PPPL ENGINEERING CHANGE NOTICE (ECN) ECN # 5140R1

ECN TITLE: Changes to Modular Coil Lead Area Design

AREA OR PROJECT: NCSX

Figure 1

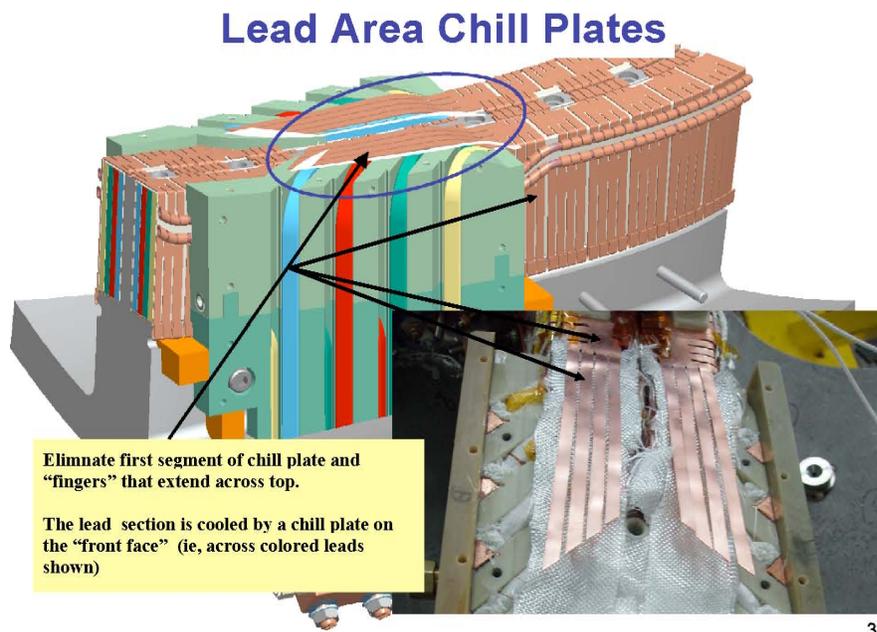
- On the top chill plate (the one with the long fingers that extend parallel to the coil) – cut off the fingers and eliminate the chill plate. **(See Figure 1)**. *This change will be implemented for the C3 and follow-on coils.*

Figure 3

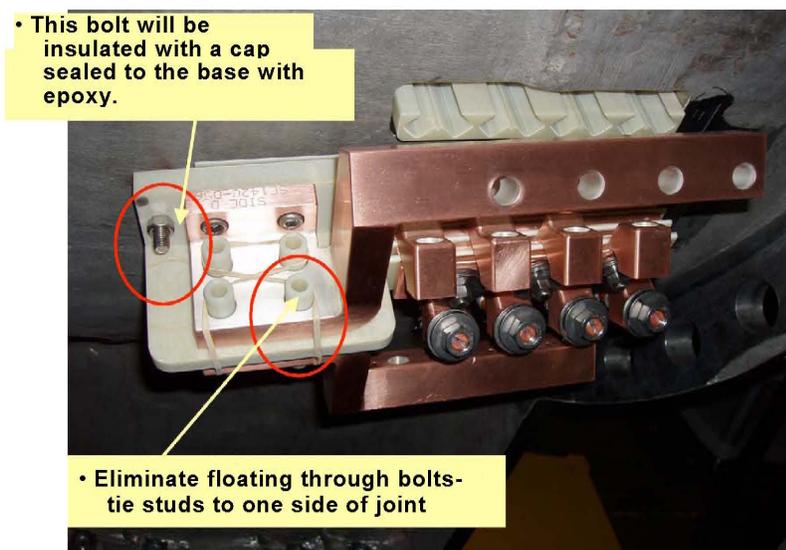
- For the power bus tie-in area, cap the attachment bolt with an epoxy seal to mitigate a potentially short tracking path.. **(See Figure 3L)**. *This will be implemented on all coils.*

- Presently the four bolts that connect the power bus are floating which is an undesirable condition **(See Figure 3R)** - connect them to one side by eliminating the insulating washers on the other side. *This will be implemented on all coils.*

Figure 4

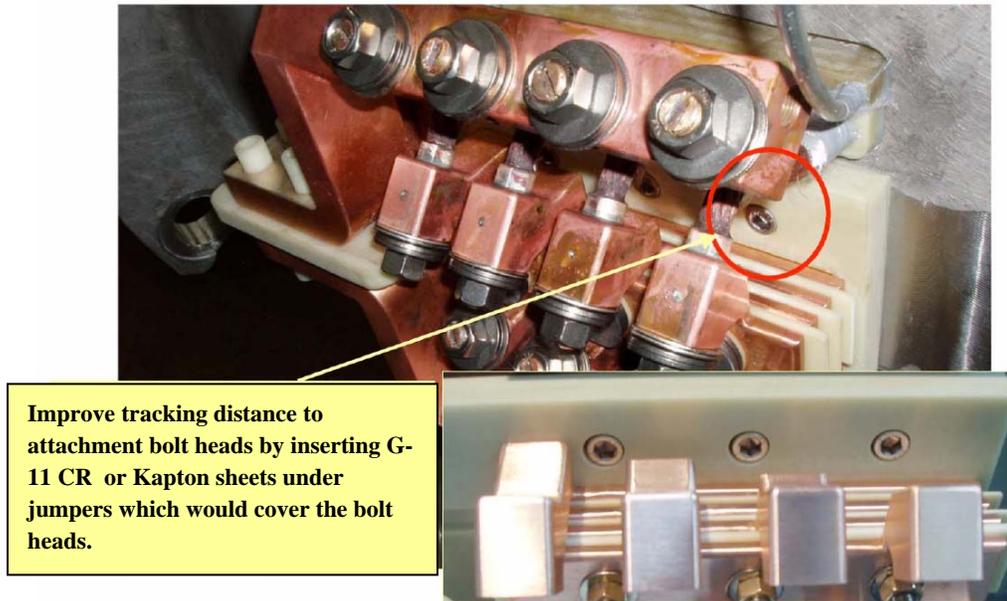
- The bolts that attach the G-11 base plate underneath the jumper stack – put a cover (Kapton or thin G-11 sheet) to increase the tracking distance. **(See Figure 4)**. *This will be implemented on all coils.*
